## **Response of AES Puerto Rico LP to EPA's September 16, 2014 Water Compliance Inspection Report**

AES Puerto Rico LP ("AESPR") hereby submits this response to EPA's September 16, 2014 Water Compliance Inspection Report ("Inspection Report"). For ease of reference, AESPR will follow EPA's Findings of the Facility Walkthrough.

Picture 35

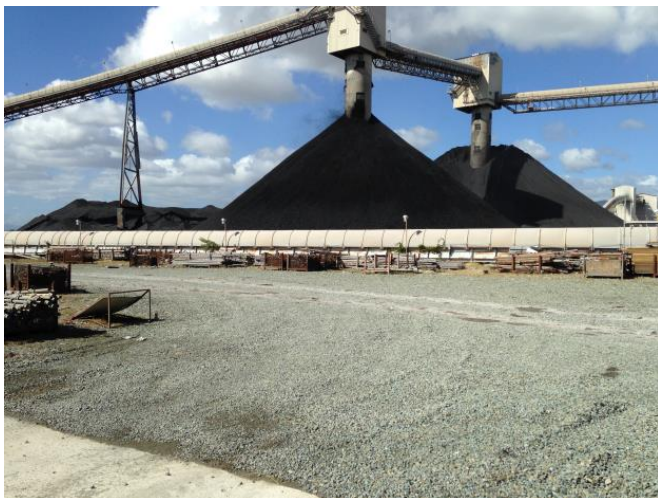
EPA Finding i.(2): The plant yards behind the south side of the limestone storage dome were observed without soil stabilization. Also, the process wastewater basin located in this area was not constructed following best engineering practices to allow for adequate sedimentation and slope stabilization. (EPA Pictures 34-35).

AESPR Response to EPA Finding i.(2): AESPR disputes the plant yards behind the south side of storage dome lacked sufficient soil stabilization. However, all site unpaved roads and unpaved areas have been stabilized further with a gravel cover. (AESPR After Picture 34). Further, AESPR disputes that there is any current compliance issue with the wastewater basin warranting further action by AESPR, as the basin is sufficient to manage storm water as needed at this area of the facility; the original design foresaw that any water collected in this area would transferred to the coal pile water run off collection pond, which is and has been occurring. In addition, an area owner has been assigned to maintain these areas to ensure they continue to be properly stabilized. This is included in the Storm Water Maintenance Matrix which is part of the SWPPP. Further, these areas will be inspected as part of the Quarterly Routine Facility Inspections.
